Re: Cherokee Nation WW Hastings Replacement Hospital - Addendum 02 Narrative

Following is a list of revisions included in Addendum 02.

PROJECT PHASE:
BID PACKAGE 02
(SITE DEMOLITION AND UTILITIES)

JOB NUMBER:	21-08.21
DATE:	10-21-2022
SHEET NUMBER:	C6-203
SHEET TITLE:	STORM DRAIN PROFILES

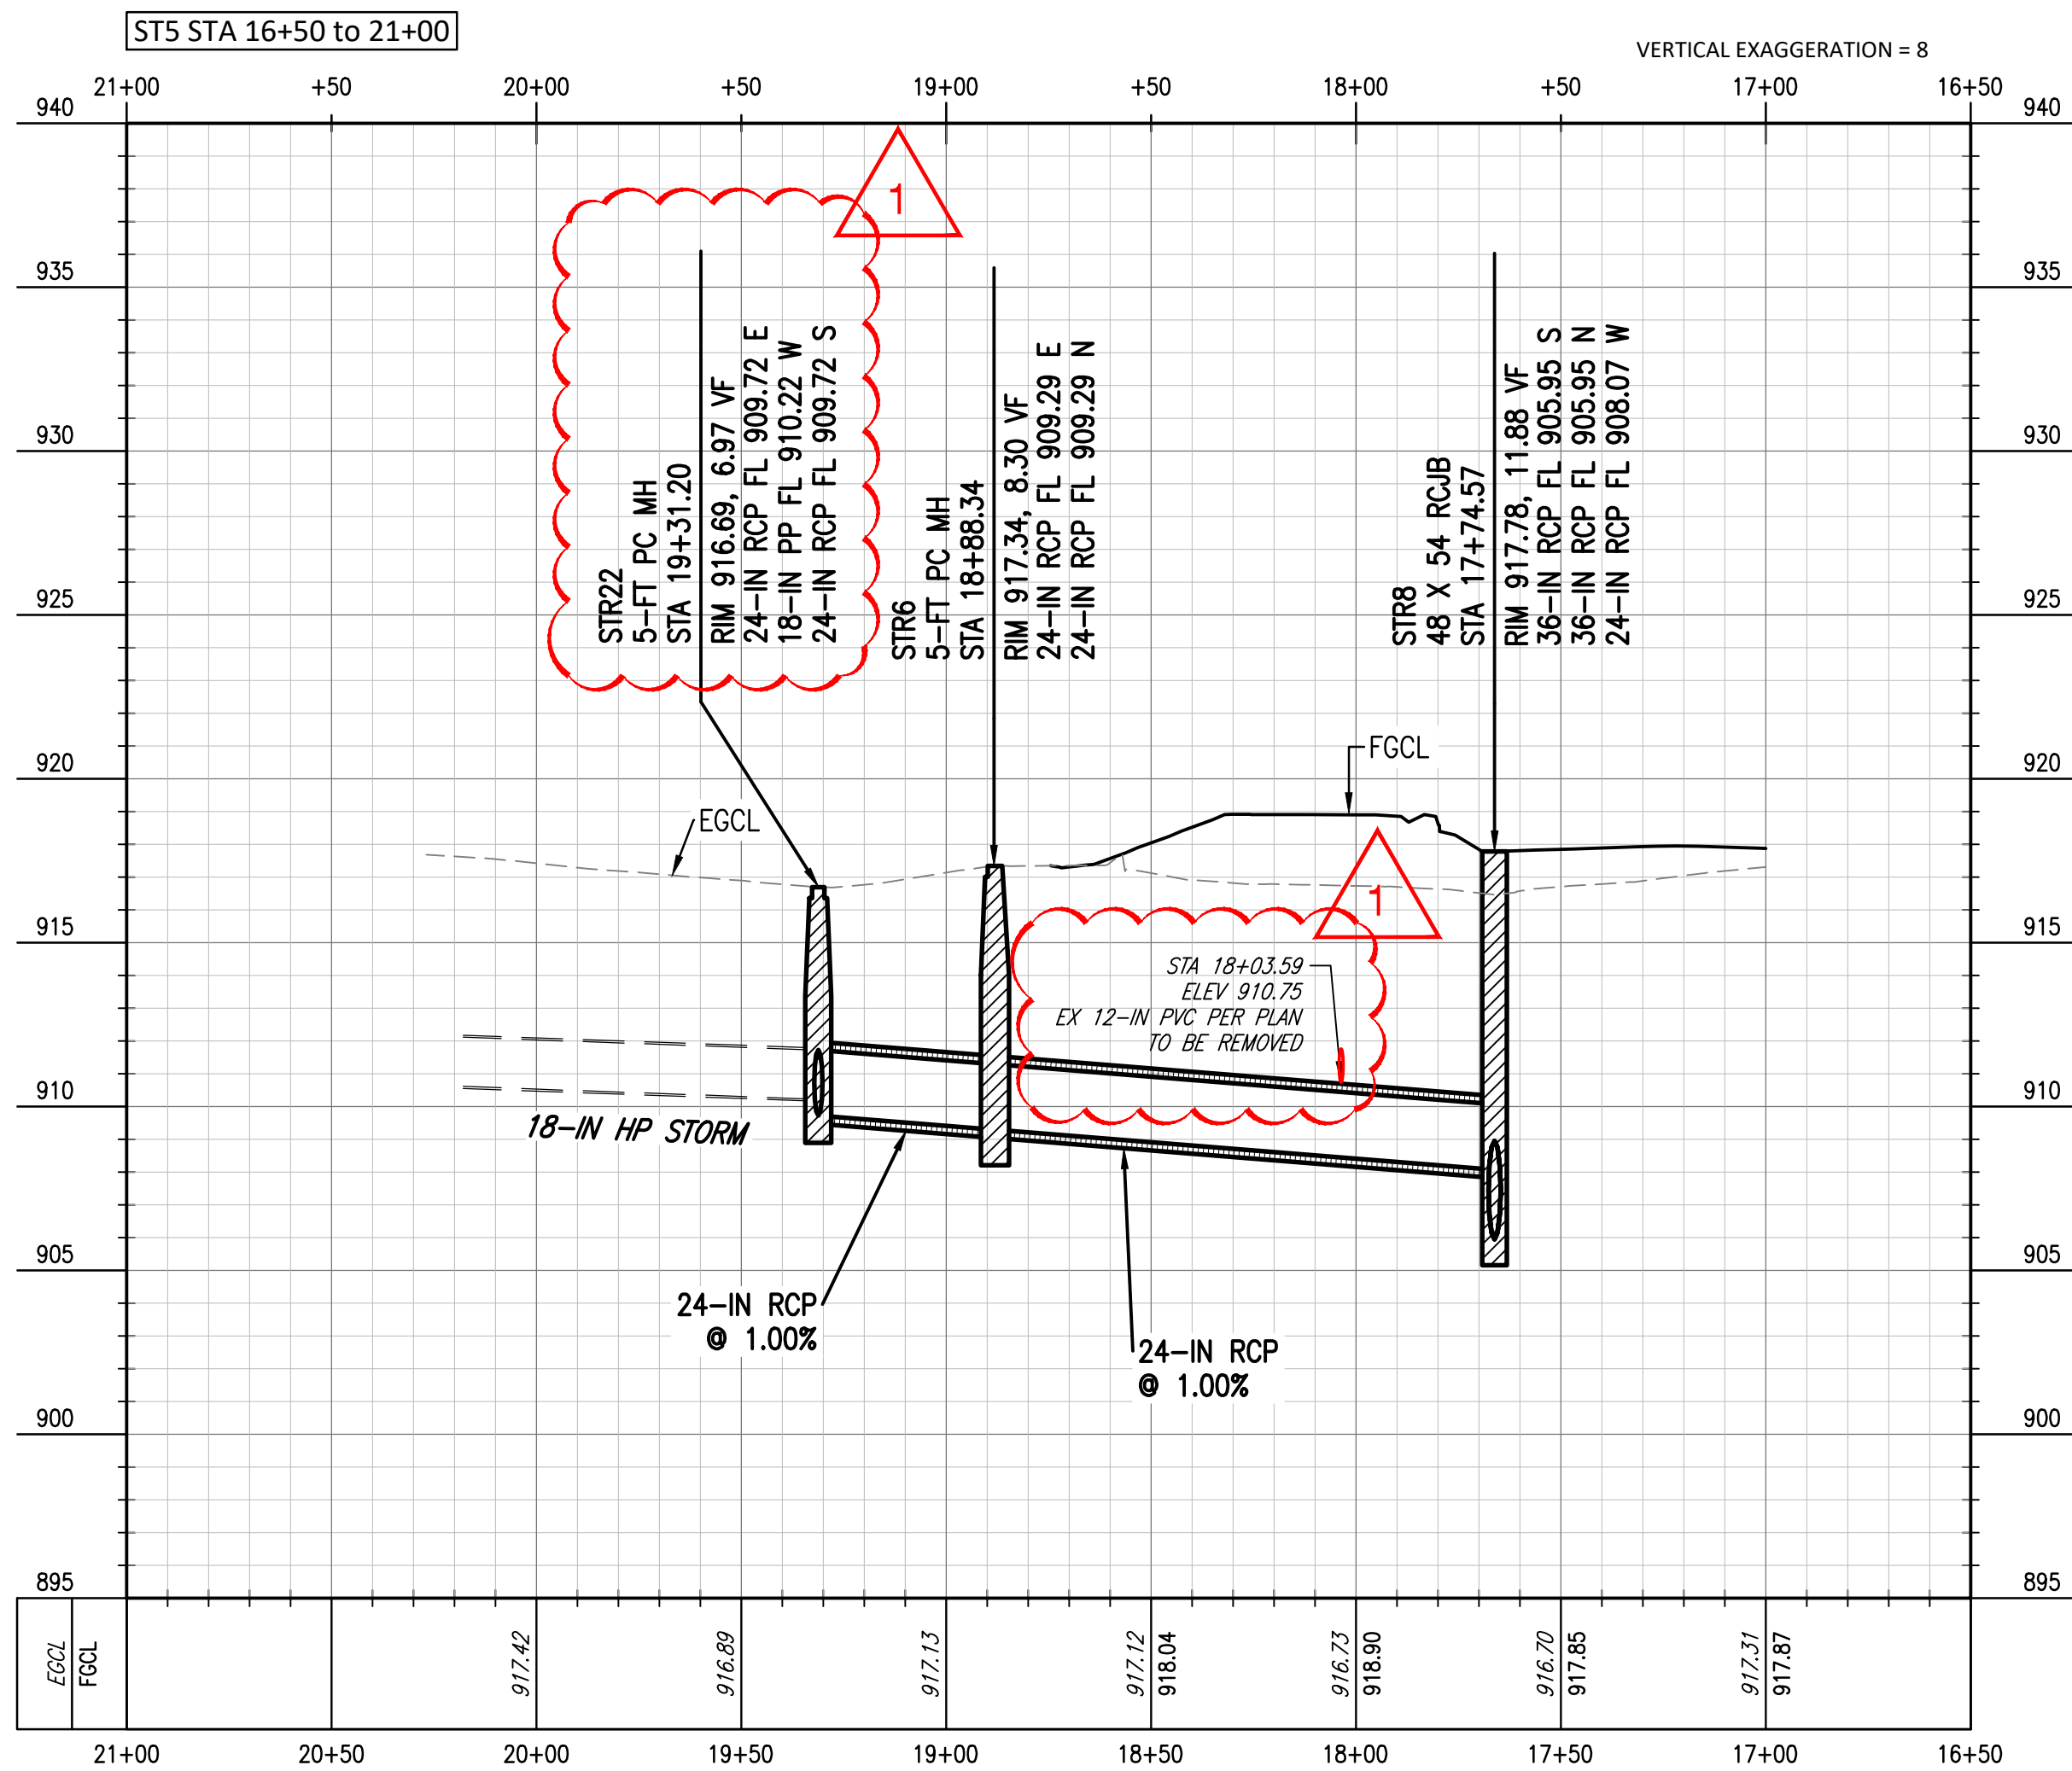
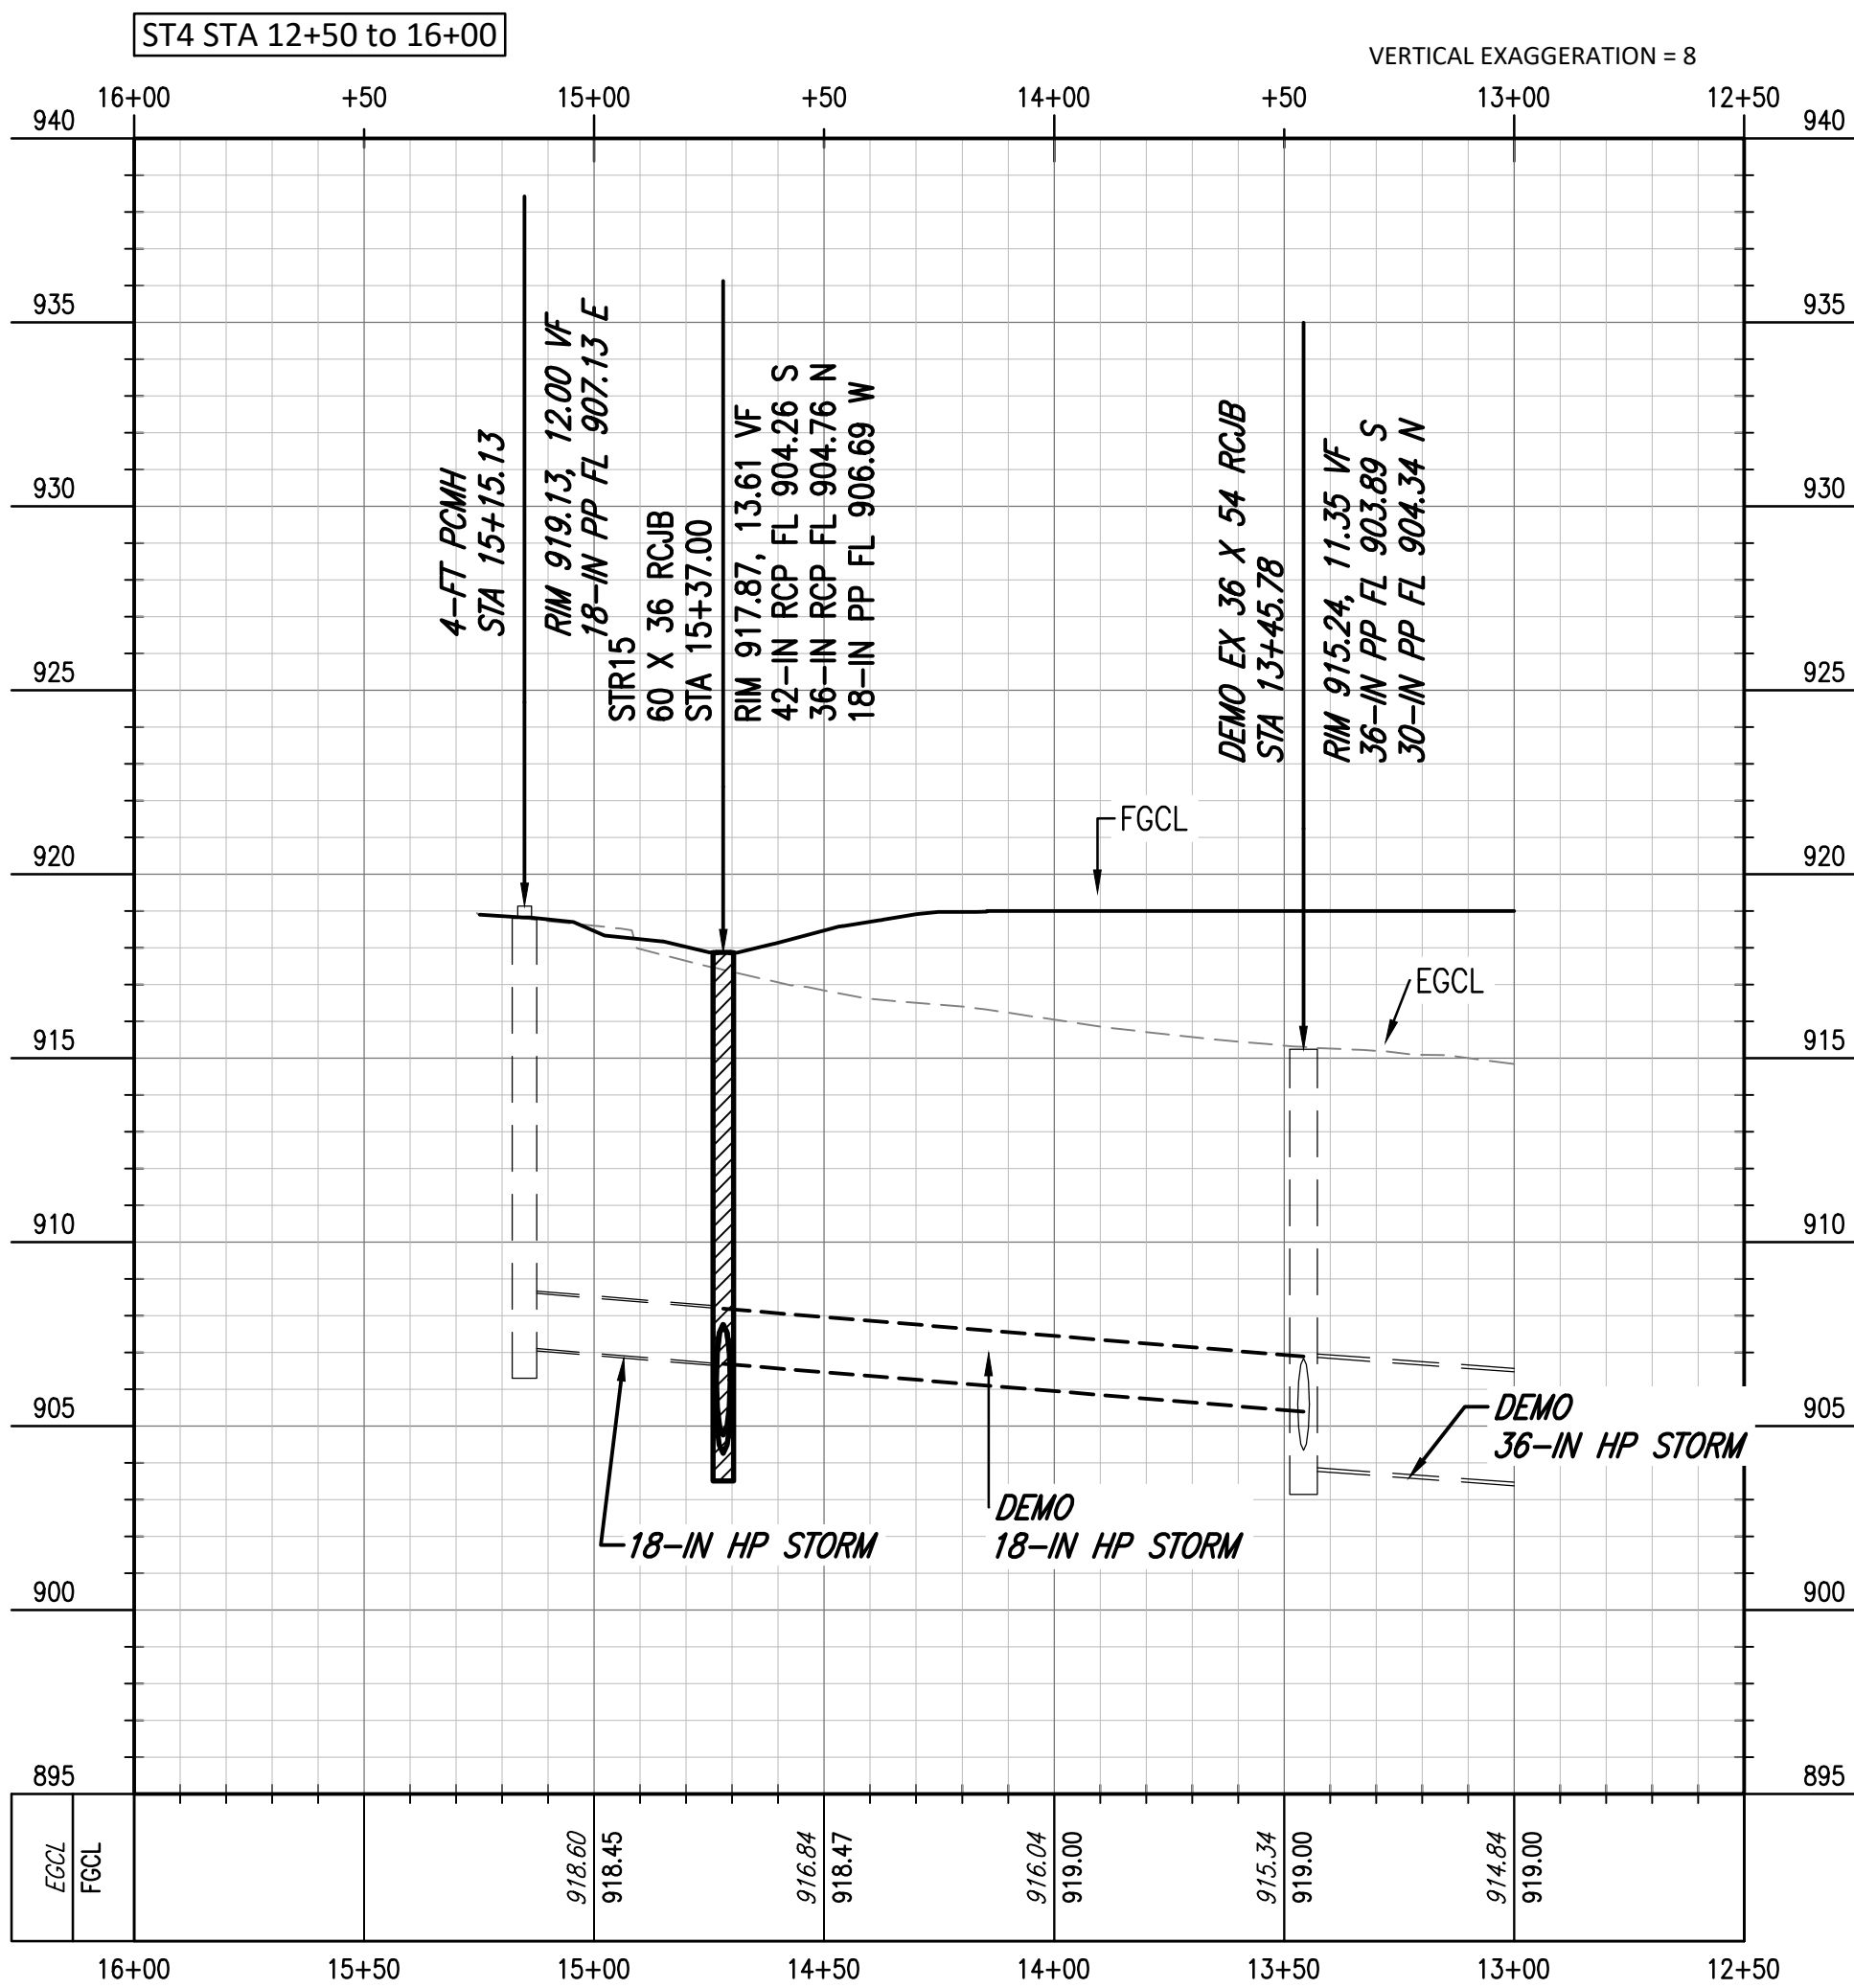
- C6-103 - Revised pipe connections to storm sewer for the lower storm sewer.
- C6-203 - Added label to STR18.
Corrected STR22 to connect the existing storm sewer pipe to the manhole.
Existing water line shown in profile ST5.
